Consideration of Petition No. 1235-14, Max Fuller, Owner, and Moore Bass Consulting, Inc., Agent, request to rezone 10.56 acres from A-R to R-45, with said property being located in Land Lot 87 of the 5th District and fronting on South Jeff Davis Road.

RE: Rezoning Petition 1235-14 and Revised Plat RP-052-14
South Jeff Davis Road Subdivision
MB Project No.: A41.008

PETITION NO: 1235-14 & RP-052-14

REQUESTED ACTION: A-R to R-45

SHEET TITLE
CONCEPTUAL PLAN
SHEET
1.0

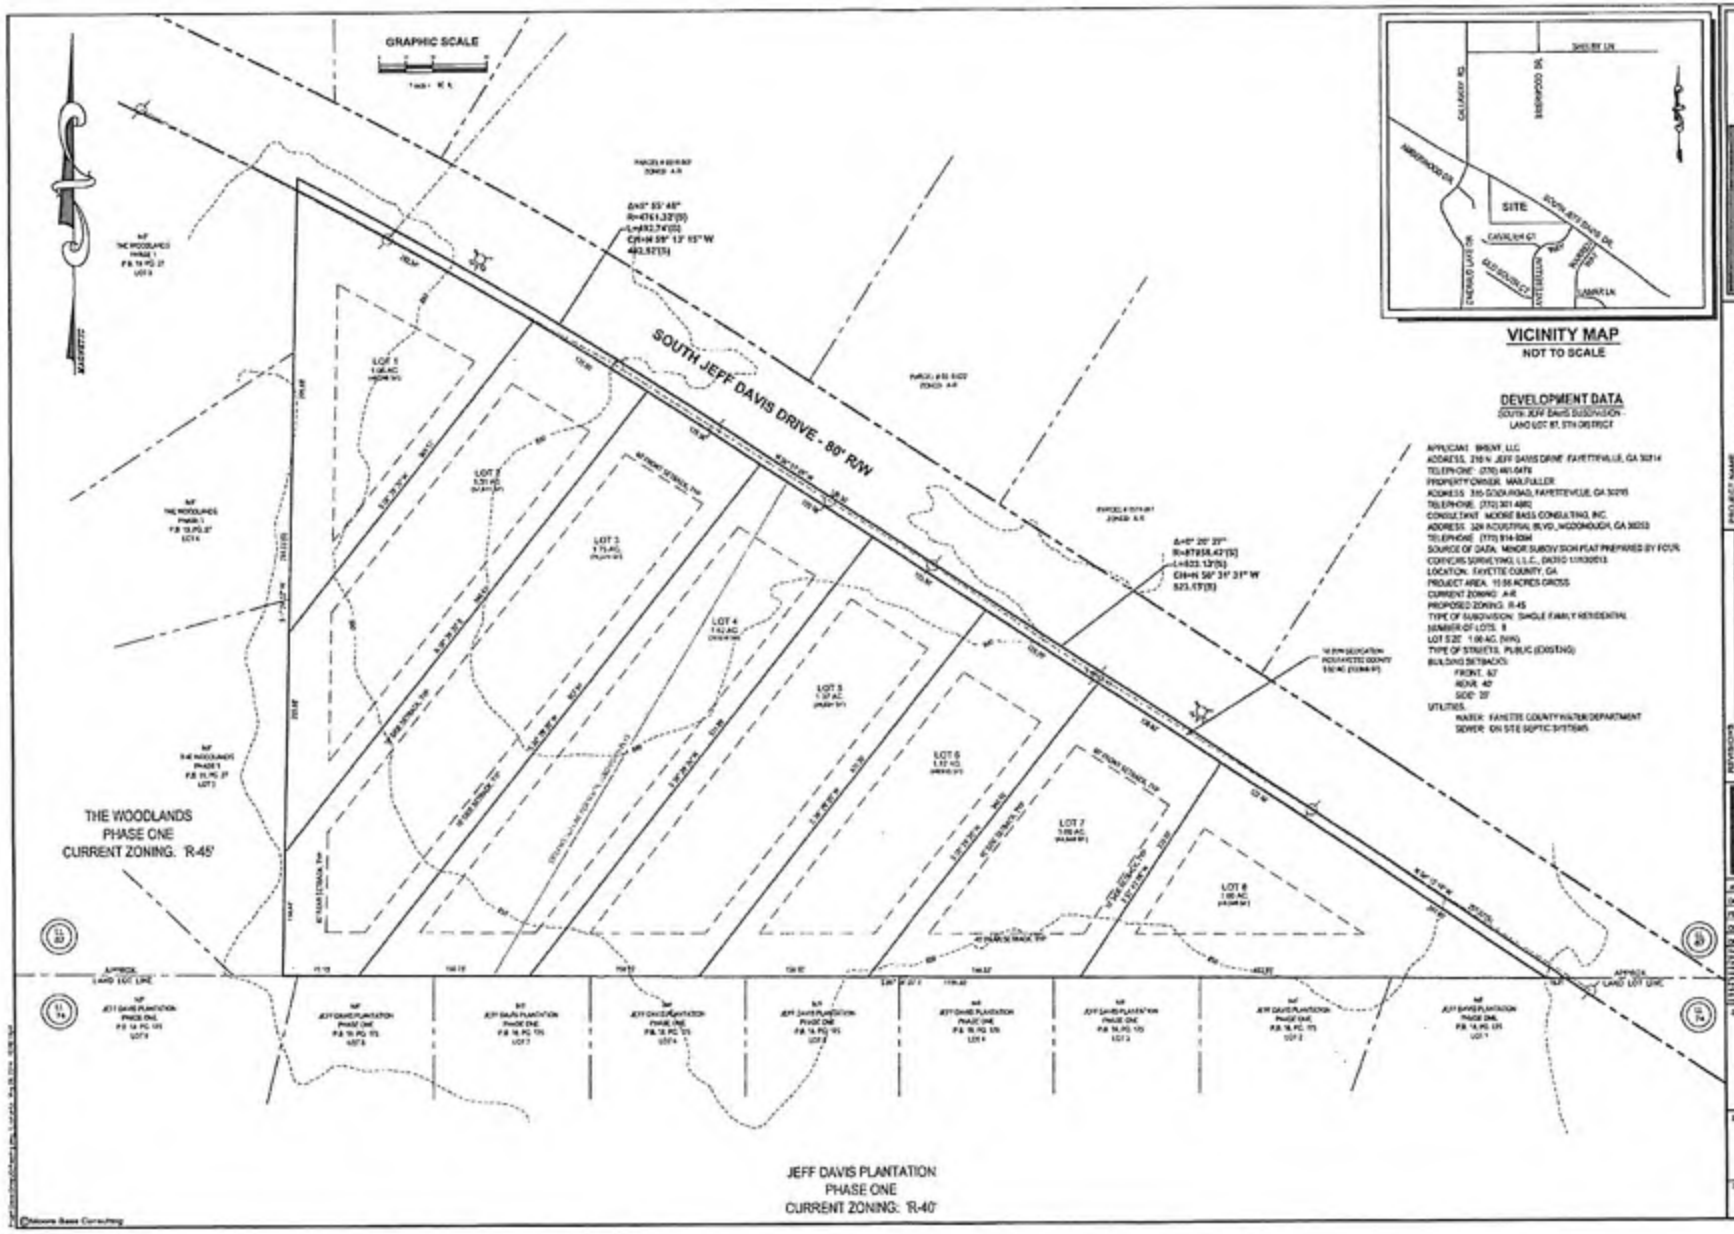
The Concept Plan submitted indicates eight (8) possible access points from South Jeff Davis Drive. South Jeff Davis Drive is classified as a Minor Arterial road on the Fayette County Thoroughfare Map. The applicant shall be aware that Public Works/Engineering has concerns with adequate site distance and may require shared driveways (see below).

1. The proposed rezoning increases number of possible curb cuts onto South Jeff Davis Road from 2 to 8 and adequate sight distance may not be available at all locations. Staff recommends that applicant determine sight distance at each proposed lot on the Revision to the Minor Subdivision Plat. Shared driveways (maximum of two homes per driveway) may be required. We do not want to create, via rezoning, a lot with safety issues to future homeowners or traveling public.

2. The increase in density will allow four times the impervious area without requirement for storm water management since no new road construction. This may impact downstream lots in Jeff Davis Plantation. Environmental Management has more input on this issue.

- Lots 1 and 2 have basically unlimited sight distance to the west or left and approximately 525-600 feet of sight distance to the right. I determined this by standing next to the fire hydrant in front of proposed Lot 1, which put my eye level at about 3.5 feet above where a driveway would be, and measuring the distance to the mailbox I could see across the street from Lot 4. I repeated this exercise in front of Lot 2.

- The lots that would be considered along the top of the hill, Lots 3, 4, and 5, have well over a thousand feet of sight distance in both directions.
- Lots 6 and 7 appear to present the biggest sight distance challenge. In my opinion, because the vertical curve in the road is so long and gradual, the required sight distance is achievable from every possible driveway location. However, if these two lots are close enough to cause concern an option could be to have them share driveways with the lots on either side of them. In other words, Lots 5 and 6 could share a driveway along their common boundary line and Lots 7 and 8 could share a driveway along their common boundary line.
- Lot 8 is more than 500 feet from the top of the hill and therefore over 500 feet of sight distance exists to the left. Sight distance to the right is well over a thousand feet.

- Bottom line seems to be that sight distance has been checked by the applicant and appears adequate for all lots. Plus option for shared driveways on lots 6 and 7, if needed.
- For final plat we'll have to double check these and possible require access easement on the appropriate lots.
